**DEVELOPMENT REVIEW BOARD MEETING  
MAY 10, 2021  
6:30 PM**

- A. Resolution No. 388. Canyon Creek 5-Lot Subdivision: Scott Miller, SAMM-Miller LLC – Applicant for William Z. Spring – Owner.** The applicant is requesting approval of a Comprehensive Plan Map Amendment from Residential 0-1 Dwelling Units per Acre to Residential 4-5 Dwelling Units per Acre, a Zone Map Amendment from Residential Agriculture-Holding (RA-H) to Planned Development Residential 3 (PDR-3) and adopting findings and conditions approving a Stage I Master Plan, Stage II Final Plan, Site Design Review, Type C Tree Plan, and Tentative Subdivision Plat for a 5-lot residential subdivision located at 28700 SW Canyon Creek Road South. The subject site is located on Tax Lot 6400 of Section 13BD, Township 3 South, Range 1 West, Willamette Meridian, City of Wilsonville, Clackamas County, Oregon. Staff: Philip Bradford

## MEMORANDUM

RE: Canyon Creek Subdivision: Important Application Changes and Hearing Protocol Information

Previous Usable Open Space Location (Tract A)

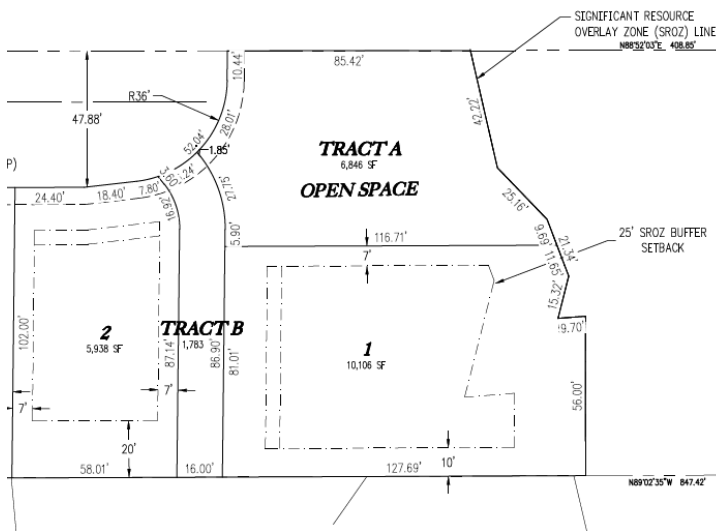
On April 29, 2021 the applicant sent staff a revised subdivision plan that includes a newly configured open space area (Tract A) which now provides 6,729 square feet of usable open space. The location of the open space is more appropriate than the previous proposal and allows clear sightlines into the usable open space area and adjacent natural area. Due to the time constraints involved in revising the open space to meet the requirement that it be designed by a registered landscape architect, the open space has been conditioned to return to the DRB for final design approval.

<p><b>PDD 14. <u>Prior to Final Plat Approval:</u></b> The applicant shall submit a revised Sheet L1 showing the landscaping plan to match the new shape and square footage of the proposed usable open space area in Tract A. <i><u>If the project landscape architect changes, the applicant shall submit a new Affidavit of Professional Credentials for Residential Usable Open Space Areas in the City of Wilsonville. For final approval of the revised open space area, the applicant shall return to the Development Review Board for review of the redesigned open space.</u></i> See Finding D49.</p>
<p><b>PDD 15. <u>Prior to Final Plat Approval:</u></b> The applicant shall revise the CC&amp;R's and Bylaws documents to require the future Homeowners Association to actively enforce no parking areas, tow any illegally parked vehicle within 12 hours, and establish fees for homeowners who violate the no parking zones. See finding D37.</p>

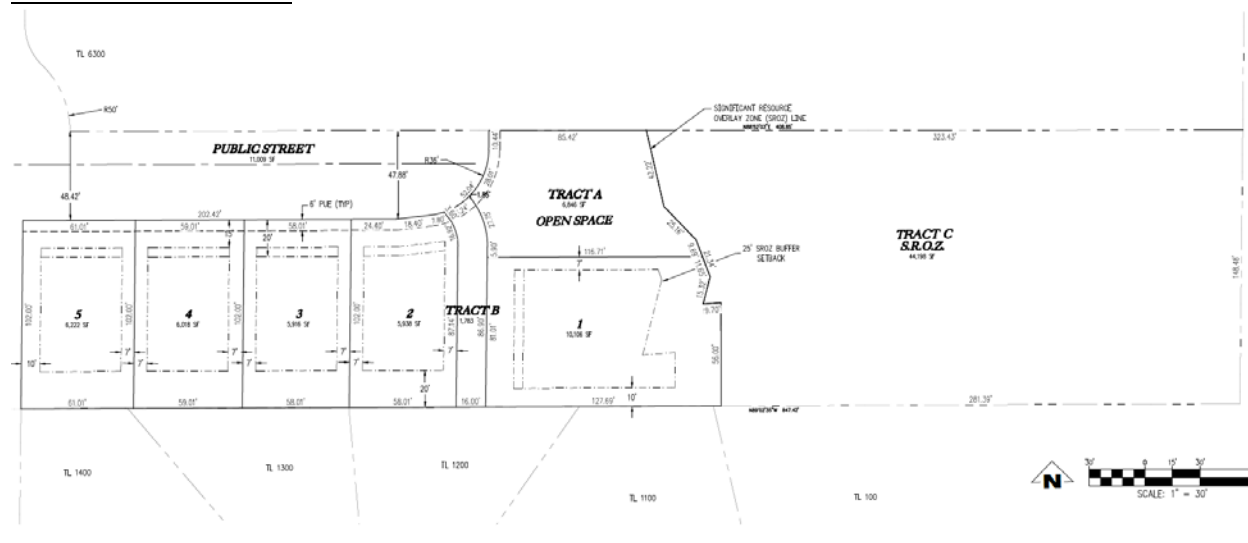
The applicant is requesting a waiver to reduce setbacks. The request includes reducing the 7 foot side yard setback as required by development standards for all residential zones to 5 feet on the

internal side yards of lots 2 and 4-7 for two-story homes. The applicant also requests a 7-foot setback on the western side of Lot 8 where 10 feet is required for corner lots by the development code in Section 4.113 Standards Applying to Residential Developments in Any Zone.

A revised layout submitted to the City on April 29, 2021 no longer shows the requested side yard setbacks that necessitated a waiver. The Applicant no longer requests the waiver application. The DRB therefore will not approve any of the previously requested waivers.

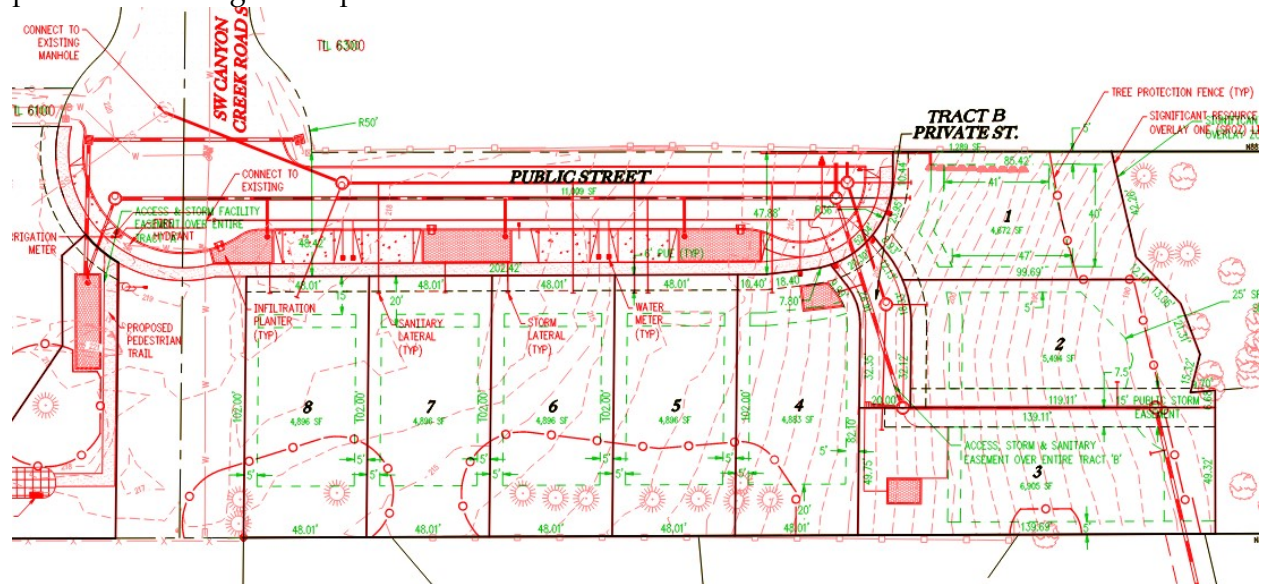
future home plans. The protection zones proposed for creation of the subdivision encroach into a substantial portion of the allowable building envelopes and it may not be feasible to provide adequate protection for these trees with home building.”

Based on when the arborist report was written, the lot numbers do not reflect the current proposal and lot numbers for the final site plan. Based on the proposed plans and arborist report, staff has concerns regarding the trees proposed for retention at the rear of lots 2-5 3 —8. The image below overlays the proposed preliminary site plan and preliminary plat and clearly shows significant overlap between the tree protection fencing and the delineated buildable area of the lots. The trees are depicted directly adjacent to the potential building envelopes.

Staff questioned the applicant on the proposed tree preservation plans as they relate to the construction of future homes on the newly created lots. The applicant’s response contained in Exhibit B5 states: “The submitted tree preservation and removal plan is specific to the construction of the subdivision only and does not include potential tree removal to accommodate the future homes. Any necessary tree removal required for lots 4-6 and 7 to accommodate future dwellings will be addressed during the building permit review process.”

By time of this staff report publication, the Applicant did not submit new exhibits showing modified building envelopes. Nor did the Applicant submit new findings and exhibits to modify the tree removal and protection plan as a result of a reduced buildable area that would not be feasible. As such, staff has included Condition of Approval PDF 9 that requires an assessment and written report by an arborist if any of these preserved trees are proposed for removal in the future due to construction; the report must provide a written explanation of the measures considered to preserve the trees along with the line of reasoning that prevents preservation, submitted to City staff, who will verify the validity through review by a second arborist.

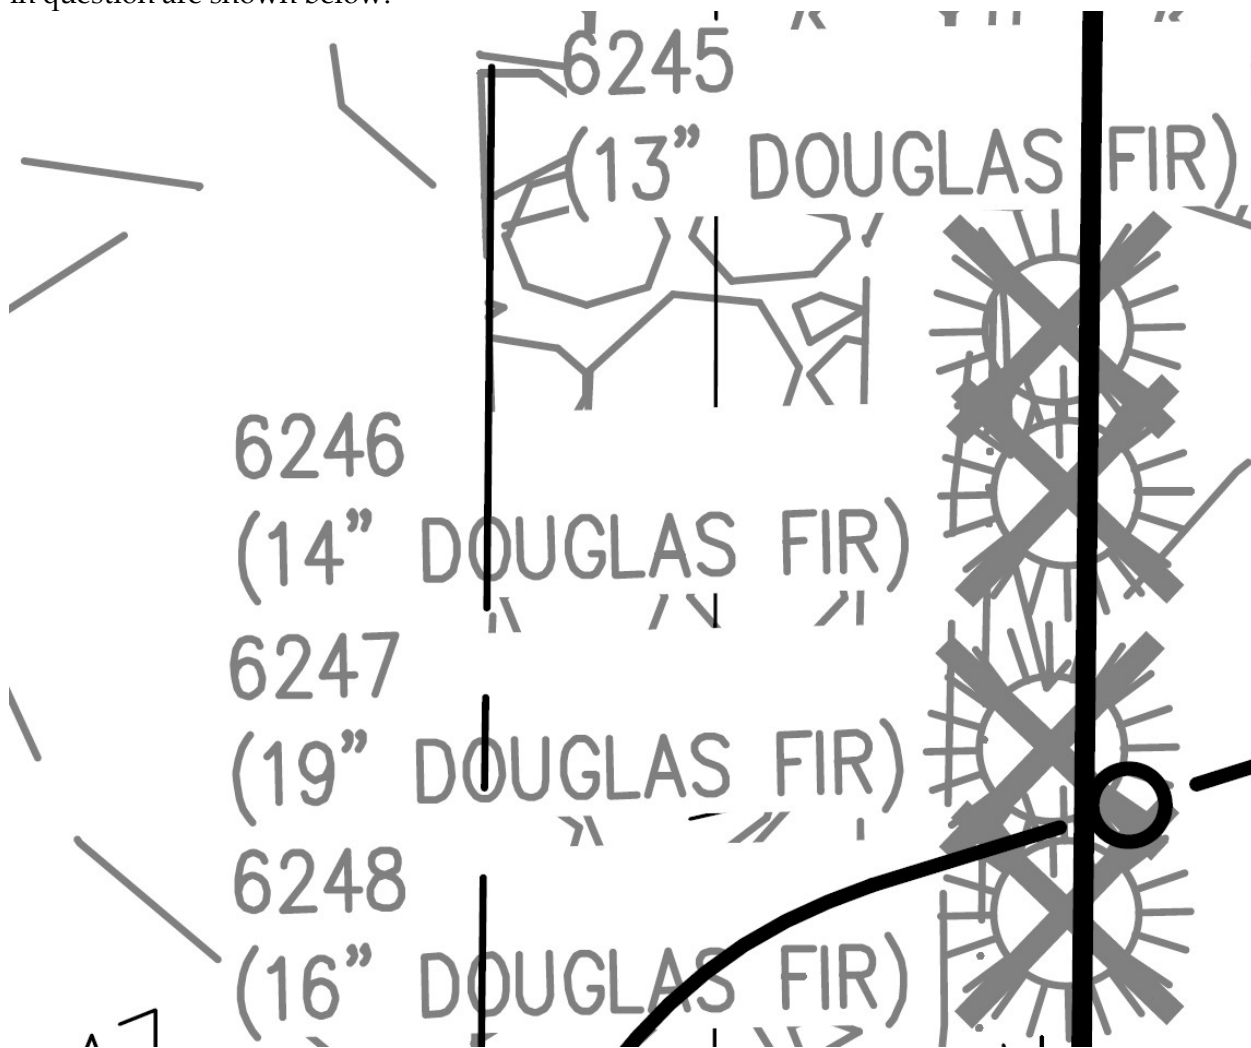
In addition to the issues concerning the trees at the rear of lots 2-5 4-8, the trees proposed for removal along the western property line of Lot 8 appear to be on City of Wilsonville property and the applicant does not have City permission to remove these trees. The trees in question are shown below:

Condition of approval PDF 8 requires Tree Numbers 6245 (13" Douglas Fir), 6246 (14" Douglas Fir), 6247 (19" Douglas Fir), and 6248 (16" Douglas Fir) shall be retained unless City approval and signature is granted for these four (4) trees. The applicant shall revise the tree protection fencing plan to ensure these trees are properly protected during grading and construction. Should these trees require removal in the future due to construction, the applicant shall provide an assessment from an arborist as outlined in Condition of Approval PDF 9, and may be removed if City Staff and an independent arborist concur that removal is necessary.
